APPLICATION NO.	FILING DATE	FIRST NAMED INVENTOR	ATTORNEY DOCKET NO.	CONFIRMATION NO.
10/752,466	01/06/2004	Thomas M. Soukup	H583.104.102	3375

Office Action Summary	Application No. 10/752,466	Applicant(s) SOUKUP ET AL.	
	Examiner Fangemonique Smith	Art Unit 3736

DETAILED ACTION

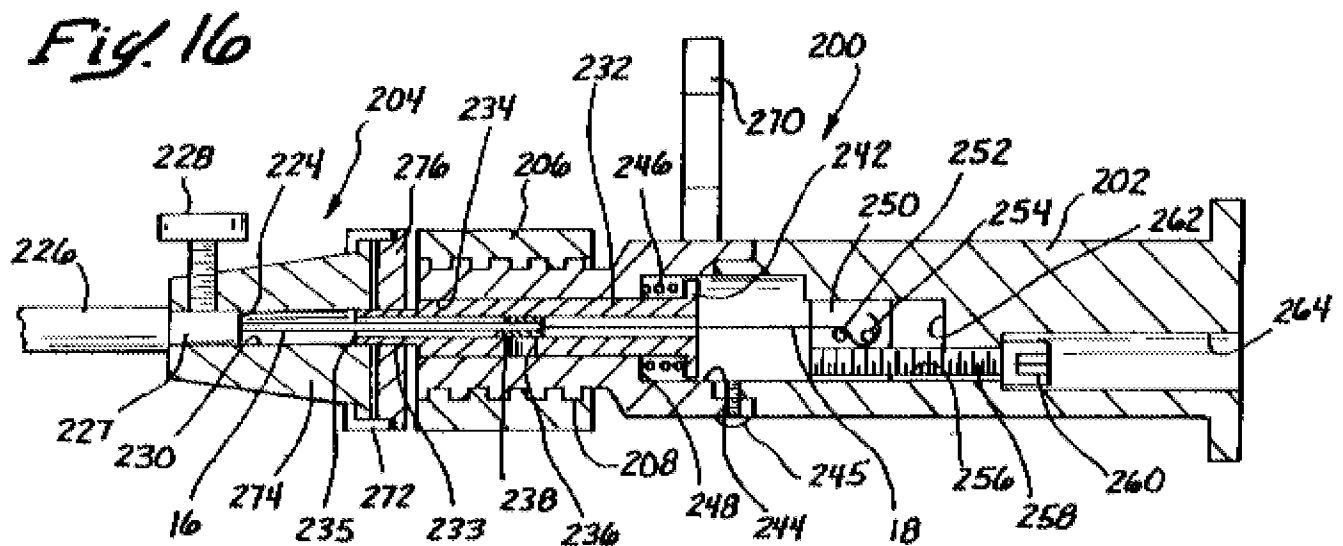
In regard to claims 60-64, 66, 77-84, 86 and 97-99, Cookston et al. disclose a deflectable stylet comprising a stylet wire (16) having a plurality of notches (82) and a core wire (18) disposed within a lumen (96) defined by the stylet wire (16) (col. 10, lines 53-67). The core wire (18) has distal portion which is adhesively secured to a section of the stylet wire (16) which is proximate to a distal portion of the stylet wire (16) (col. 7, lines 8-19). The device disclosed by Cookston et al. further includes an adjustable tensioner mechanism (206) which is operably connected to the device for applying a tension force between the stylet wire (16) and the core wire (18) (col. 13, lines 12-67). The device includes a tension limiter (258) which is operably arranged for limiting the tension force between the core wire (18) and the stylet wire (16). Cookston et al. disclose the device returning to an original position upon removing tension force from the stylet wire (col. 13, lines 45-67; col. 14, lines 1-18). The tension limiter is capable of limiting the tension force on the device to a limit force that is less than the breaking force of the stylet wire (col. 13, lines 12-21). The tension limiter includes a constant force spring (246) which delivers a maximum

tensile strength force which is less than the breaking force of the stylet wire (col. 13, lines 12-67; col. 14, lines 1-49). The tensioner limiter mechanism engages with the compressible spring to increase a force opposing movement of the tensioner. The device disclosed by Cookston et al. is shown in Figure 16 below.

Cookston et al. disclose the features of the Applicant's invention as described above. Cookston et al. do not disclose the spring operably arranged between the adjustable tensioner mechanism and a proximal portion of the stylet wire which is spaced apart from the distal region. Lundquist et al. disclose a steering mechanism including a steering shaft coupled to a controller which includes a handle apparatus for manipulating the distal end of the shaft. The steering shaft has a flexible coiled spring having a lead spring in a fixed position relative to the distal end of the shaft. Lundquist et al. disclose the device including a tension adjusting mechanism which is accessible without disassembling the apparatus and allows adjustment of the tension of the
